UNITED STATES PATENT AND TRADEMARK OFFICE

APPLICATION NO.	FILING DATE	FIRST NAMED INVENTOR	ATTORNEY DOCKET NO.	CONFIRMATION NO.
09/688,837	10/17/2000	Shusuke Yamamoto	001358	1853
7590	03/15/2005		EXAMINER	
ARMSTRONG, WESTERMAN, HATTORI McLELAND & NAUGHTON 1725 K Street, N.W. Suite 1000 Washington, DC 20006			FERGUSON, MICHAEL P	
			ART UNIT	PAPER NUMBER
			3679

Office Action Summary	Application No.	Applicant(s)	
	09/688,837	YAMAMOTO ET AL.	
	Examiner	Art Unit	
	Michael P. Ferguson	3679

DETAILED ACTION

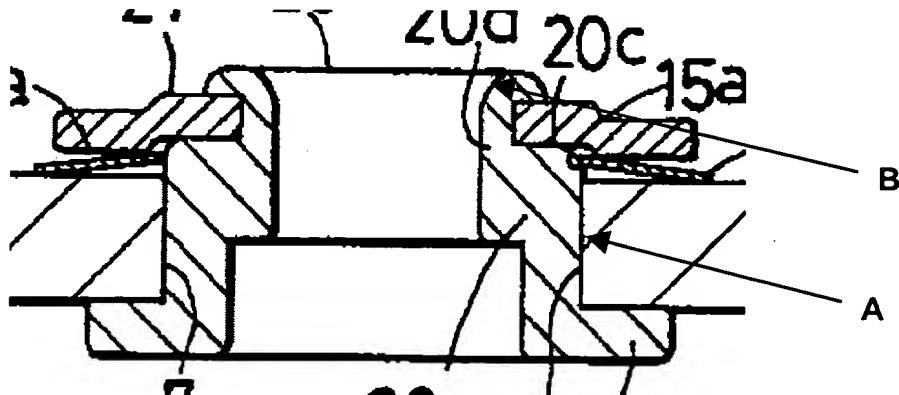
a hollow pin 20 having a shaft portion 20a which does not have a step on an outer surface of an intermediate portion A (intermediate portion A has a constant diameter A; Figure 8(b) reprinted with annotations below) inserted into each of the inserting holes with a washer 21 fitted on an end portion 20d of the hollow pin which is caulked radially outward for fixing the washer in position, an inner diameter portion of the end portion being only slightly expanded by caulking the hollow pin, and wherein the expansion does not exceed an outer diameter A of a shank 20a of the pin, wherein an outer peripheral surface (outer cylindrical surface) of the hollow pin is not beveled but has an angular (cylindrical) shape,

a spring 15 provided between a washer 21 at a caulking side of the hollow pin and a washer 18 at a hub/disc side of the hollow pin,

wherein the hollow pin is formed (**subsequent to caulking**) into a rounded or arced convex shape in the end portion of the pin in a part of its inner periphery to the extent that the end portion has no sharply bent edge (rounded edge B) on which the caulking pressure is applied (Figures 8(a)-9).

Examiner disagrees. As to claim 6, Yamamoto et al. disclose a pin connection structure having a hollow pin **20** having a shaft portion **20a** which does not have a step on an outer surface of an intermediate portion **A** (intermediate portion **A** has a constant diameter **A**); wherein an outer peripheral surface (outer cylindrical surface) of the hollow pin is not beveled but has an angular (cylindrical) shape; and a spring **15** provided between a washer **21** at a caulking side of the hollow pin and a washer **18** at a hub/disc side of the hollow pin; wherein the end portion of the pin has no sharply bent edge (rounded edge **B**) on which the caulking pressure is applied (Figures 8(a)-9).
